Alberni Valley & Bamfield Services Committee Meeting

Somass Watershed Flood Management Plan (SWFMP) Peer Review **10-73**

To: Alberni Valley and Bamfield Services Committee
From: Mike Irg, GM of Planning and Development
Meeting Date: December 1, 2021
Subject: Somass Watershed Flood Management Plan (SWFMP) Peer Review

Somass Watershed Flood Management Plan Peer Review

Figure 2-2 : BC Tsunami Notification Zones

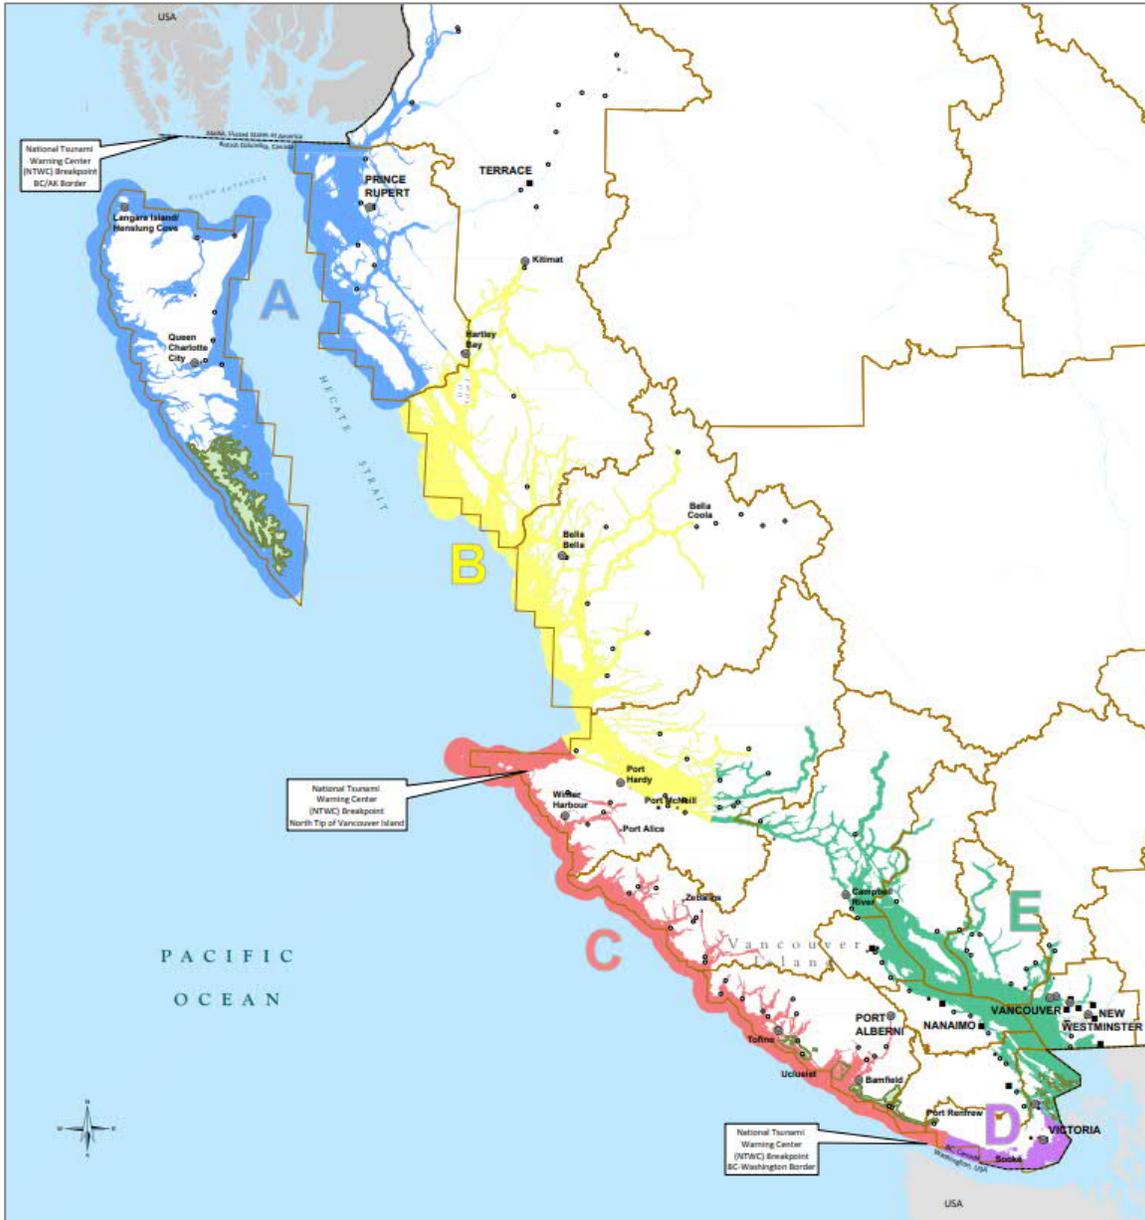
The main consideration that arose from the review of Appendix C of the NHC Flood Assessment Report, is that tsunami hazard was not considered. The Flood Hazard Area Land Use Management Guidelines (2018) states that areas subject to significant tsunami hazard, as defined in the by zones A, B, C, and D of the tsunami notification zone shown in Figure 2-2, should consider tsunami hazards. However, this was outside of the NHC Scope of Work.

20 Page 18	The main consideration that arose from the review of Appendix C of the NHC Flood Assessment Report, is that tsunami hazard was not considered. The Flood Hazard Area Land Use Management Guidelines (2018) states that areas subject to significant tsunami hazard, as defined in the by zones A, B, C, and D of the tsunami notification zone shown in Figure 2-2, should consider tsunami hazards.	As noted by Hatch, assessing and/or mapping tsunami hazards was outside NHC's scope of work.

Figure 2-3: Sproat Lake Weir 1956 Design Drawing

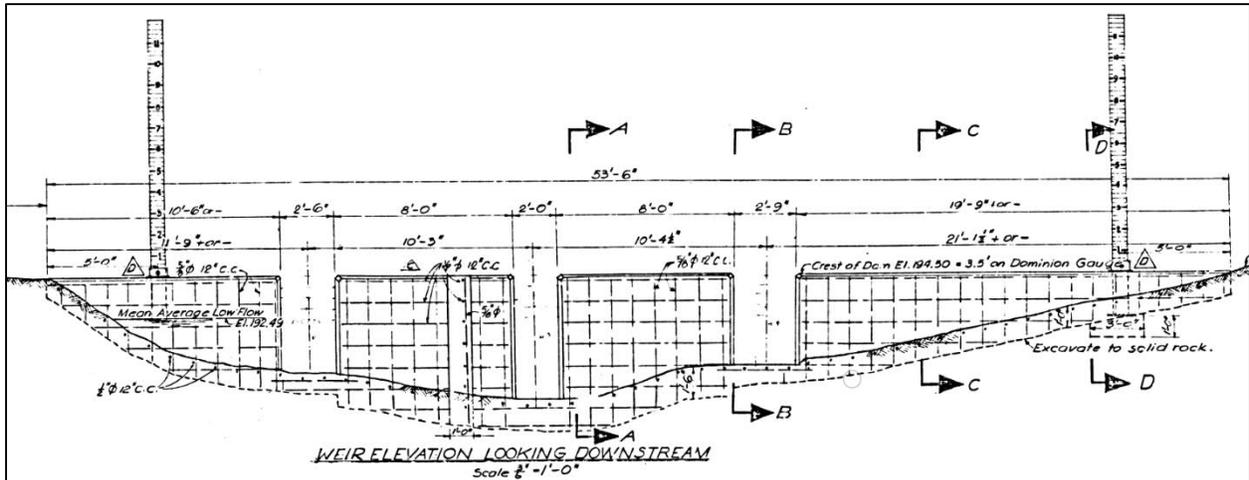
Hatch reviewed the Sproat Lake weir. The design drawing from its construction in 1956 is shown in Figure 2-3. As stated in NHC's report, it is owned and operated by Catalyst for the purpose of maintaining lake levels for the mill water supply pipeline. NHC has noted an important observation that the lake level control has shifted over time, where higher lake levels have been measured post-1956, the year the weir was established. The relationship between Sproat River flows and Sproat River lake levels for 1913-1996 is demonstrated in a figure in their report and is copied in Figure 2-4 below for discussion.

The NHC report and model demonstrate a weir crest elevation of 27.3 m in the Sproat Lake outlet channel with a thalweg of 26.74 m (i.e. a visible weir height of 0.56 m) on the upstream side of the weir. The weir is 19.35 m in length along the lake bed. The provided original 1956 design drawing “D51000_D 51004” includes a drawing with rating curve, which has been transcribed and converted to metric and to the same elevation datum as used in the NHC study (using the weir crest elevation of 27.3 m as the benchmark reference) to facilitate the peer review, and is presented below in Table 2-4. This drawing demonstrates a greater maximum weir height of 1.1 m at the deepest section. It is noted that the profile view of the lake to channel thalweg (extracted from the NHC report and shown in Figure 2-5) demonstrates what could be an accumulation of material behind the weir, as there is a distinct rise in the channel thalweg for approximately 25 m upstream of the weir, followed by a drop to elevation 25.63 m on the downstream side of the weir. This material could potentially be eroded with the removal of the weir, back to its presumptive natural state. Additional analysis would be required to confirm if this is a possibility. This does not appear to be covered in the geomorphology section. If this is the case, and it is only the weir that is removed in the model simulation but not the material, this could lead to artificially higher losses in the simulations.

completed to determine the “new” flood frequency lake levels and corresponding flow, as the entire flow regime could change. The analysis presented in NHC’s report appears to assume that the flood conditions are unchanged, and the weir is simply removed from the system. The conclusion is that the weir is already backwatered from the downstream constriction, so its removal would not affect the presented flood levels. However, it appears that the control shifts at some point during the flood regime, so flood levels for the smaller, less frequent events would be reduced. This will influence the economics, as the flood damage curve will decrease at the lower end of the spectrum. This should be taken into account in any risk comparison studies. It is recommended that this analysis be completed to determine the system effects of removing the weir in order to quantify its impact.

Figure 2-5: Sproat Lake Outlet Channel Profile View (NHC)
(shown for Mitigation Scenario 4 – widened constriction compared to baseline conditions)

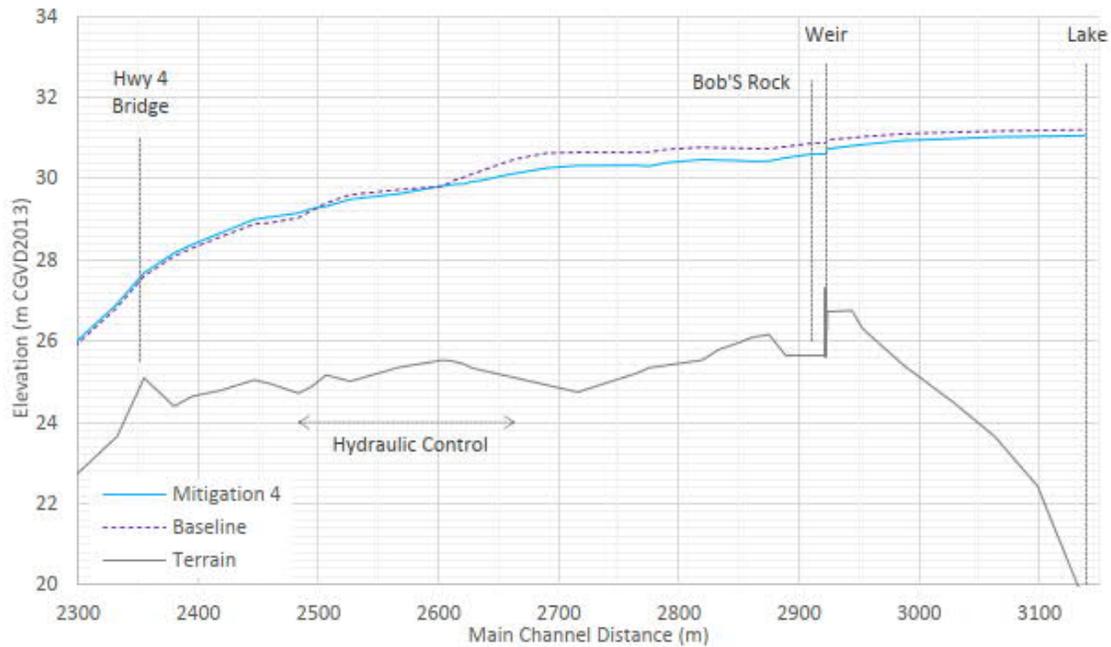
The overall results of the geometry modification assessment indicate a constriction in the long narrow portion of the outlet channel that is the ultimate control of the water levels and discharge at Sproat Lake. In reviewing the available data and geometry, this conclusion appears to be accurate and reasonable for higher return period floods.

26 Page 32	It is noted that the profile view of the lake to channel thalweg (extracted from the NHC report and shown in Figure 2-5) demonstrates what could be an accumulation of material behind the weir, as there is a distinct rise in the channel thalweg for approximately 25 m upstream of the weir, followed by a drop to elevation 25.63 m on the downstream side of the weir. This material could potentially be eroded with the removal of the weir, back to its presumptive natural state. Additional analysis would be required to confirm if this is a possibility. This does not appear to be covered in the geomorphology section. If this is the case, and it is only the weir that is removed in the model simulation but not the material, this could lead to artificially higher losses in the simulations.	A large rock excavation was completed at the time of construction of the weir to help mitigate potential flood impacts of the structure. The lake outlet was widened from pre-weir conditions. The hydraulic control for the lake outlet during flood conditions of more than about 200 m ³ /s is farther downstream (about 260 to 430 m downstream of the weir for an outflow of 300 m ³ /s). Additional analysis is possible to assess the effects of the weir on lower discharges, but once flows get to about 200 m ³ /s the weir is essentially drowned out (NHC App B Fig 6; BC Provincial letter and engineer's report from 1968). In other words, the weir and any bed forms upstream of it do not have any effect during flood events such as the 2016 flood when lake outflow was 300 m ³ /s.
